**Better Beehive Group Cambridge**  
**Objection to Beehive Centre Redevelopment – planning application ref.**  
**23/03204/OUT (September 2024 revision)**

**BBCG object to the proposals within the revised Beehive planning application. We support the redevelopment of the Beehive site in principle and would advocate for a further reduction in number of buildings, height and mass in favour of a mixed-use development to include retail and residential use.**

Figure 3 : Degrees of warming in the Cambridge urban areas. Shown in red are the existing heat effects in parts of Petersfield, Romsey and the Kite area.

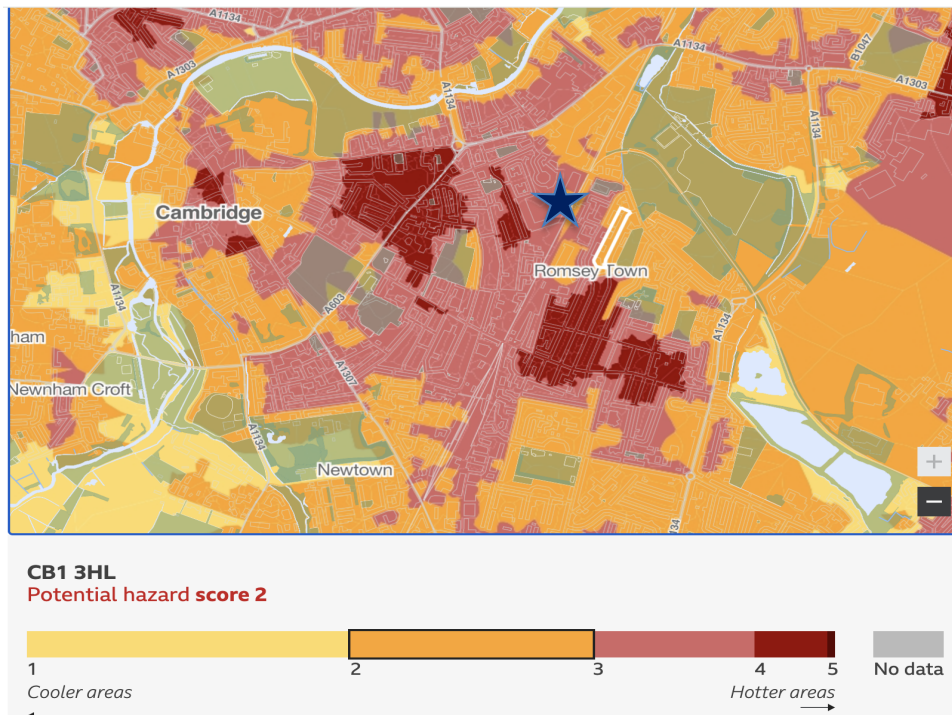
7.19. The intensification of the existing Urban Heat Island Effect (UHIE) is shown in the image below for the Romsey, parts of Petersfield and The Kite areas. Published by the BBC in July 2022.

- 7.20. The Beehive site is indicated by the star, to the northwest of the railway between the dark red areas. The development would exacerbate the UHIE as a result of its additional vertical hard surfaces and roofscapes unless further measures are taken to mitigate the effect. Additional amplification of the problem may also result from the redevelopment of the Grafton Centre.
- 7.21. We note the assessment of building materials that might help in avoiding some of the extra loading of the UHIE. We also recognise the Urban Green Factor exercise carried out for the site. The information in the DAS states that the soft landscape proposals have been measured and calculated in line with Natural England Research Report NERR132 - Urban Greening Factor for England and government guidance on surface types.
